Access Compliance Report

Public Rights-of-Way

(Curb Ramps)

Intersection ID: 15074	Main Street: MAGNOLIA_AV	Cross Street: PARK_RD	Location: SW
ADA ID: 2A69471837B0	Ramp Type: Perp	Initial Pass/Fail: Fail	Overall Compliance: No
Codes/Mitigation Info/Possible Solution		Field Measurements/Component Compliance	
Severity Score: 12.5

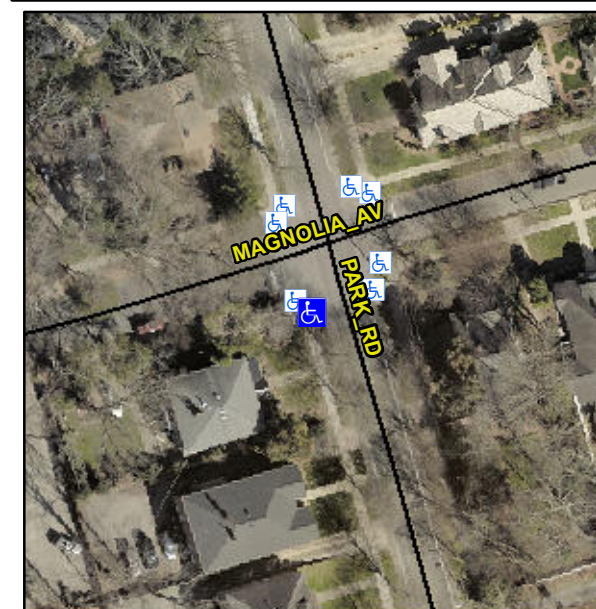
R304.5.3

Compliance	Description	Data	Compliance	Description	Data
N/A	Ramp Length (in)	66.0	Yes	Ramp Slope (%)	5.8
Yes	Ramp Width (in)	48.0	No	Ramp XSlope (%)	5.5
N/A	Flare Type LT	N/A	N/A	Flare Type RT	N/A
N/A	Flare Slope LT (%)	N/A	N/A	Flare Slope RT (%)	N/A
N/A	Flare Traversable LT?	N/A	N/A	Flare Traversable RT?	N/A
N/A	Landing Length (in)	N/A	N/A	DWS Provided?	N/A
N/A	Landing Width (in)	N/A	N/A	DWS Contrast?	N/A
N/A	Landing Slope (%)	N/A	N/A	DWS Length (in)	N/A
N/A	Landing X Slope (%)	N/A	N/A	DWS Full Width?	N/A
N/A	Landing Curb? (Y/N)	N/A	N/A	DWS Offset (in)	N/A
N/A	Shared Landing?	N/A			
N/A	Gutter Ponding?	N/A	N/A	Gutter Slope (%)	N/A
N/A	Gutter Lip Ht (in)	1.0	N/A	Gutter X Slope (%)	N/A
N/A	Painted X Walk1?	No	N/A	Painted X Walk2?	N/A
	X Walk 1 Direction	To E		X Walk 2 Direction	N/A
N/A	X Walk 1 Width (in)	N/A	N/A	X Walk 2 Width (in)	N/A
	X Walk 1 Slope (%)	4.3		X Walk 2 Slope (%)	N/A
	X Walk 1 X Slope (%)	0.3		X Walk 2 X Slope (%)	N/A

Remove & Replace Entire Ramp.
